**MONTGOMERY COUNTY HISTORIC PRESERVATION COMMISSION**  
**STAFF REPORT**

<b>Address:</b>	3713 Underwood St., Chevy Chase	<b>Meeting Date:</b>	7/13/2022
<b>Resource:</b>	Clark House <b>Individually Listed Master Plan Site</b>	<b>Report Date:</b>	7/6/2022
<b>Applicant:</b>	Hannah Graae & Duke Schaeffer	<b>Public Notice:</b>	6/29/2022
<b>Review:</b>	HAWP	<b>Tax Credit:</b>	n/a
<b>Case Number:</b>	997705	<b>Staff:</b>	Dan Bruechert
<b>Proposal:</b>	Skylight Installation

**EAST ELEVATIONS**

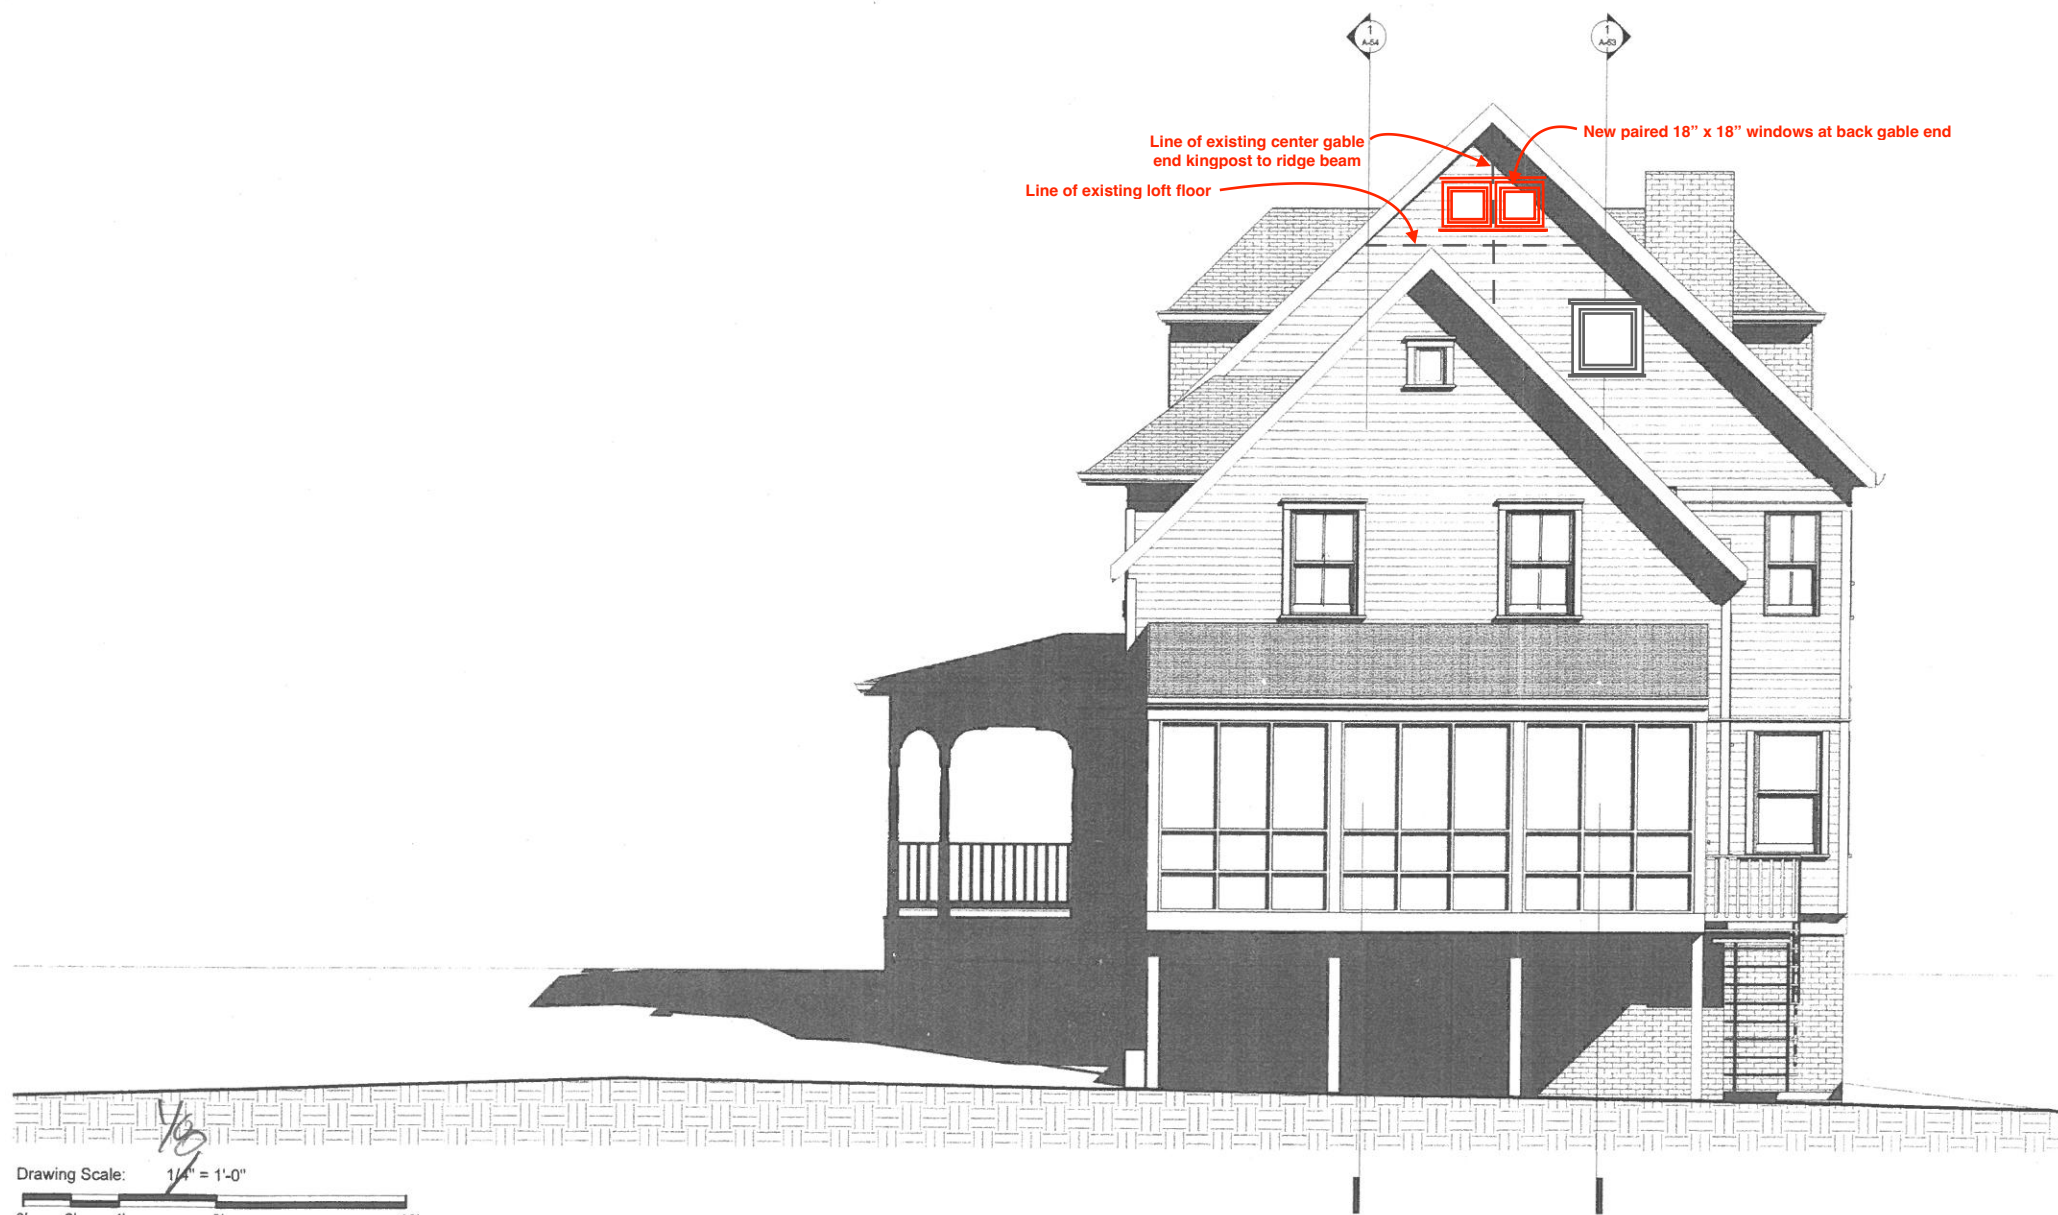
Staff considered several factors in evaluating the appropriateness of the proposed skylights. First, Staff considered whether any skylights were appropriate at the subject property. As an individually listed Master Plan Site, its review needs to be relatively restrictive. Staff first determined that the historic roofing material is gone and all that remains is a contemporary asphalt shingle roof. Next, Staff considers the impact skylights would have on the roof form. The existing roof is a front gable with hipped dormers on the left and right roof slopes. A low-profile skylight would project approximately 2" (two inches) above the roof plane. Staff finds that while this would disrupt the roof form, its impact is less than solar panels which would likely be acceptable on these roof slopes. Staff concludes that the subject property can accommodate some skylights on the roof.

The second question is whether the proposed skylight arrangement is compatible with the architectural character of the historic resource. Staff's initial recommendation was to locate the skylights as far from the front as possible to best preserve the resource's historic character. The recommendation included potentially placing one skylight to the rear of the dormer. However, in conversations with Staff, the applicant stated the that arrangement would be unsatisfactory because of the attic space's interior arrangement. Staff next considered only a single skylight on each roof slope, but concluded that a single skylight looked unbalanced and tended to stand out more than a pair of skylights. Staff concluded that the proposed two skylight arrangement was appropriate and would not detract from the character of the house. Staff finds the proposal is consistent with 24A-8(b)(2).

Staff recommends that the Commission **approve** the HAWP application under the Criteria for Issuance in Chapter 24A-8(b)(2) having found that the proposal will not substantially alter the exterior features of the historic resource and is compatible in character with the district and the purposes of Chapter 24A;

NORTH ELEVATION 12

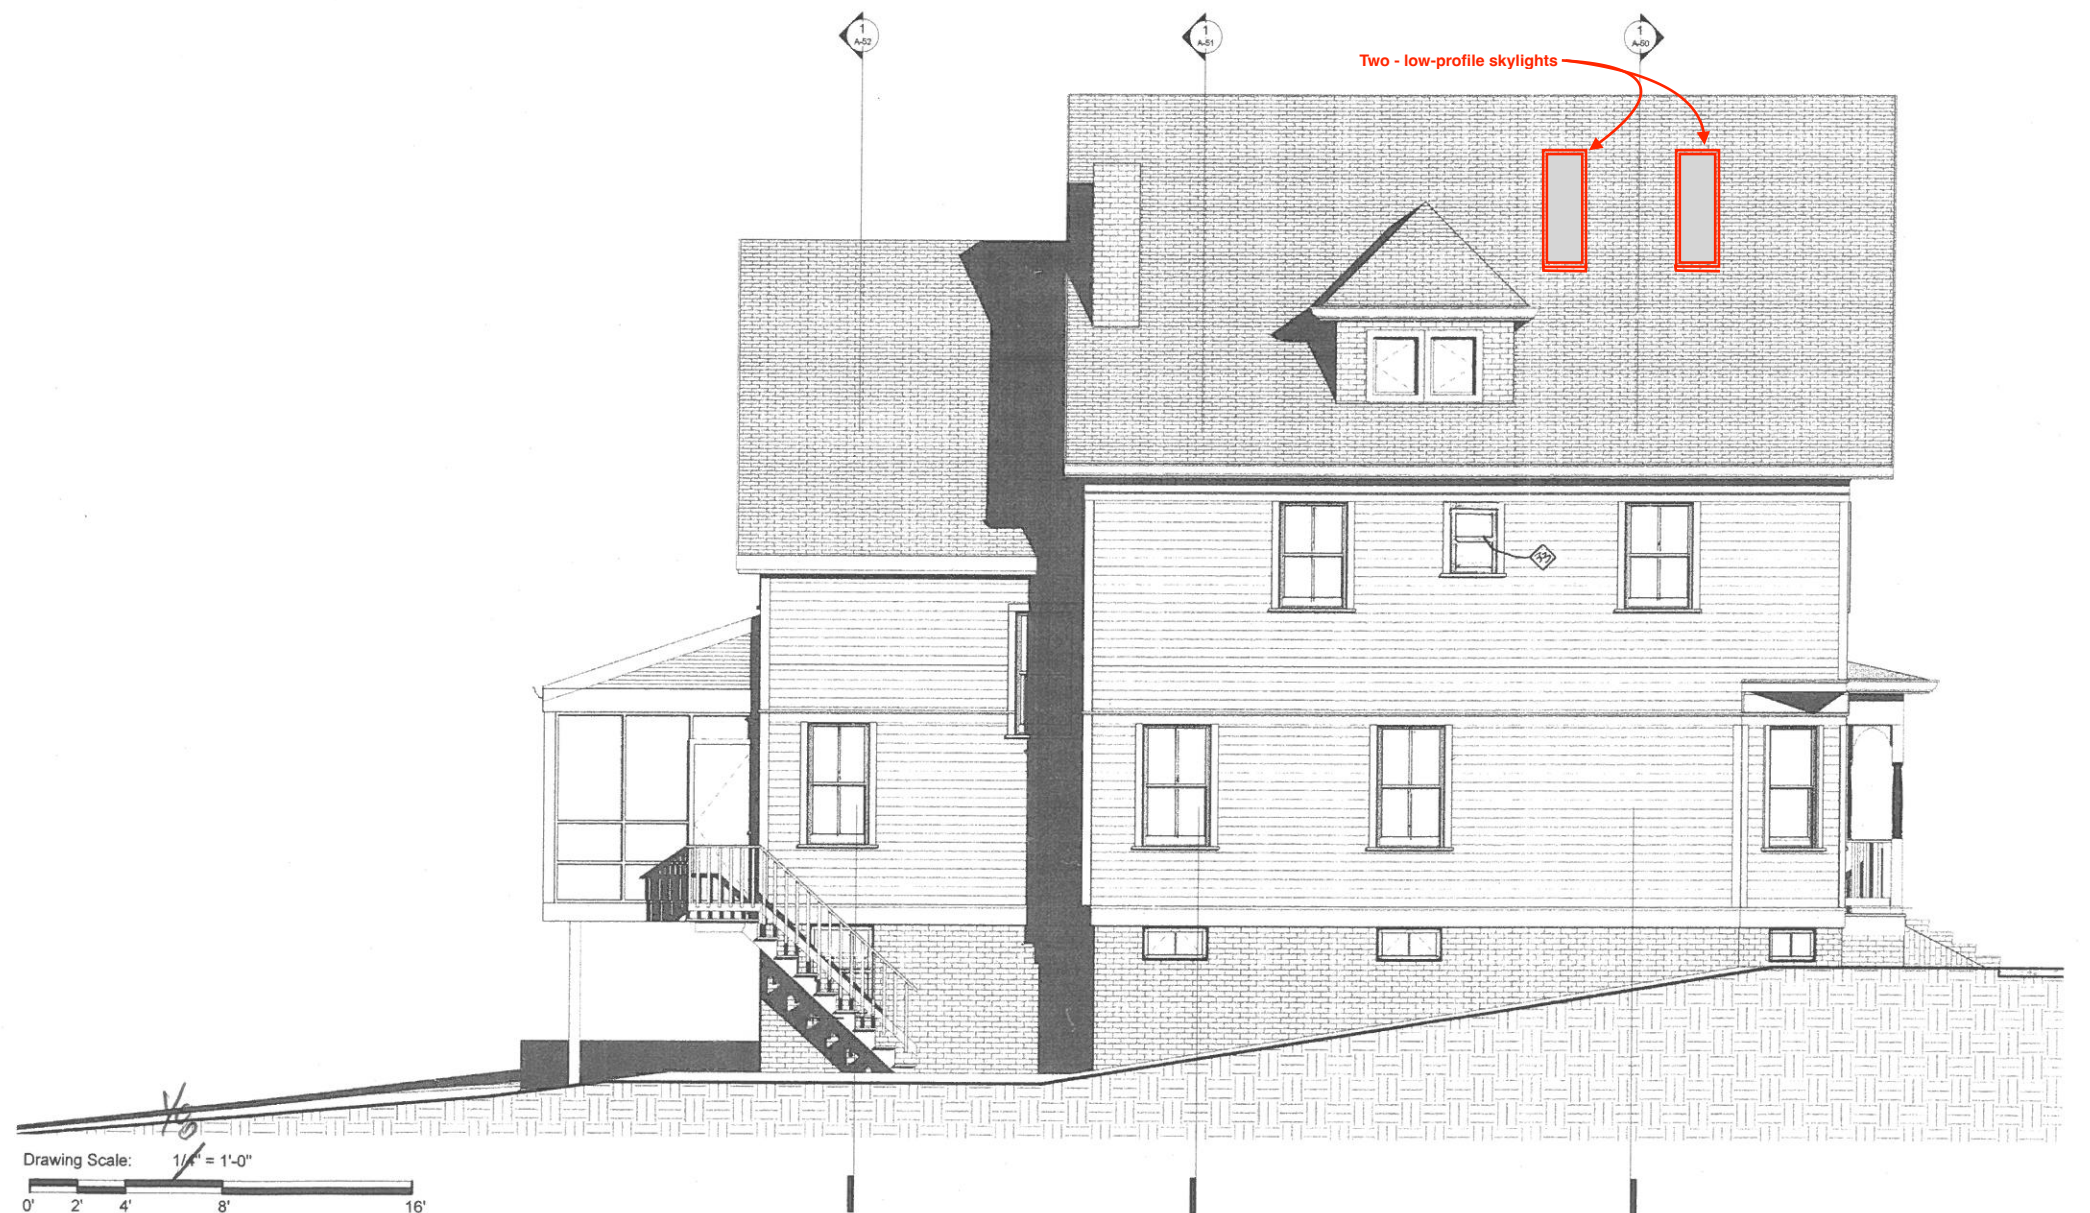
Staff finds the pair of wood casement windows on the rear of the house are compatibly designed and will not have a significant impact on the character of the historic house and Staff recommends the HPC approve the pair of rear windows under 24A-8(b)(1) and (2) and Standards 2.
